Fingerboards Mineral Sands Project

Expert Witness Statement of Hugh MIDDLEMIS (Groundwater Expert)

28th January 2021

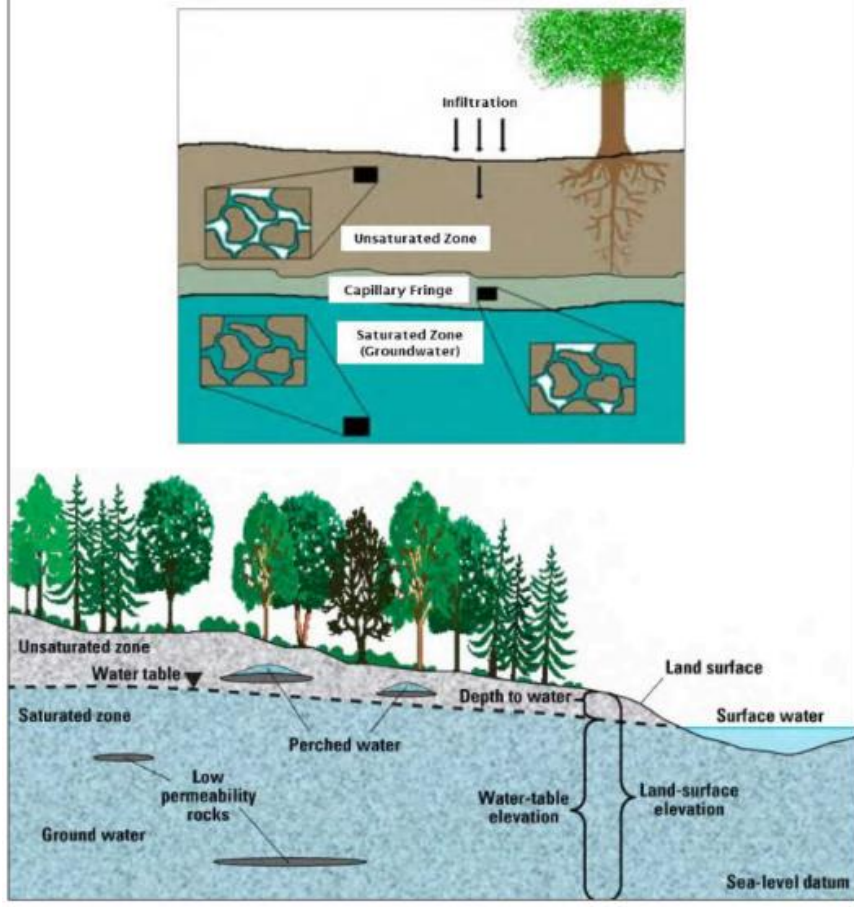
Item	Groundwater-related Concerns, Comments and/or Issues	Submission#	Response by Groundwater Expert Mr Hugh Middlemis
	<p>c) Submission 813 suggests that the groundwater modelling is oversimplified, downplaying the possibility of perched aquifers above the base of the mine and underestimating mining activity impacts on groundwater mounding and groundwater dependent ecosystems (GDEs).</p>		<p>depressurisation effects due to a combination of mining and offshore petroleum well production is represented appropriately via drain cell features.</p> <p>Submission 813 does not specify which bores it is referring to about potential interference effects. It may possibly be assuming that only the four (eastern) bores that lie within the options area will be permitted, in which case the extraction rates would have to increase in order to yield the 95 L/s total, and thus drawdowns will increase. However, it is also possible that licensing and other negotiations may allow some latitude in borefield layouts. Nonetheless, the effects on third party bores as predicted will be different if the borefield location and layout is different from that presented in the EES. However, the EES predictions and uncertainty analysis do provide an objective assessment of the incremental borefield drawdown effects, including potential interference effects.</p> <p>c) It is worthwhile establishing a definition for ‘perched aquifer’ conditions, before discussing potential implications. With reference to the conceptual hydrogeological terminology graphic shown below (after Doody et al. 2019), groundwater may be defined as water contained within and completely saturating the pore spaces associated with rocks and sediments below the ground surface (ie. generally in the saturated zone below the regional water table). Perched groundwater may be defined as an isolated region in the unsaturated zone (ie. below the ground surface and above the regional water table) where the pore spaces associated with rocks and sediments may be locally saturated where they overlie a low permeability lens, thus forming a limited extent ‘perched’ groundwater lens. By definition, perched conditions are isolated and not connected to the regional water table and are not affected by drawdown of the water table. Similarly, perched conditions are generally not affected by mounding of the water table, unless the mound rises to establish saturated water table conditions above the low permeability lens.</p>

Item	Groundwater-related Concerns, Comments and/or Issues	Submission#	Response by Groundwater Expert Mr Hugh Middlemis
			 <p data-bbox="1254 1133 2105 1204">Figure 1. Top: difference in saturation among particles in the unsaturated zone, capillary fringe and saturated zone (Michigan State University 2018); bottom: perched aquifers in the unsaturated zone, which can be an important water source for some GDEs (Snyder 2008)</p> <p data-bbox="1254 1212 2105 1252">Conceptual hydrogeological terminology (after Doody et al. 2019)</p> <p data-bbox="1254 1308 2105 1452">At Fingerboards, the depth to water table is typically more than 30 metres (except near the Gippsland Lakes, on main river floodplains and in creeks and gullies north of the mine area). The mounding that develops due to mining activities is largely</p>

Item	Groundwater-related Concerns, Comments and/or Issues	Submission#	Response by Groundwater Expert Mr Hugh Middlemis
			<p>constrained to the mine area, with steep hydraulic gradients at the edge of the tailings cells, as shown by many figures in section 7 of the Groundwater Assessment (Appendix B to EES Appendix A006).</p> <p>Although the ‘mounding’ (as defined by the 0.5 metre contour illustrating the lateral spreading of the significant mounding that develops under the mine path) extends up to 4 km from the mine, the mounding effect outside the mine area is generally less than 2 metres. This means that the depth to regional water table is not materially affected by mounding outside the mine area, and thus there is a very low potential for water table mounding effects on any perched conditions that may exist, such as in the Providence Ponds area.</p> <p>Finally, I note that low permeability horizons was considered in the risk-based impact assessment (Appendix A006, Table 8-8).</p> <p>As there almost no evidence of perched aquifer conditions, especially in the mine area, in my view the groundwater modelling has not been ‘oversimplified’ and thus it does not underestimate mining activity impacts on groundwater mounding or GDEs. In fact, in terms of perched aquifer issues, the Fingerboards model is consistent with previous East Gippsland Groundwater Modelling that was conducted by GHD in 2010 on behalf of the Victorian government agencies for the Ensym/ecoMarkets initiative and was independently peer reviewed. Such an approach is consistent with best practice guiding principles (eg. Barnett et al. 2012, section 3), in that: <i>“In regional problems where the focus is on predicting flow, predictions depend on large scale spatial averages of hydraulic conductivity rather than on local variability. Moreover, in large regions there may be insufficient data to resolve or support a more variable representation of hydraulic conductivity. A parsimonious approach may be reasonable, using constant properties over large zones, or throughout a hydrostratigraphic unit”</i>.</p> <p>In any case, even if isolated perched conditions exist above the base of the mine, the mining process would remove the</p>
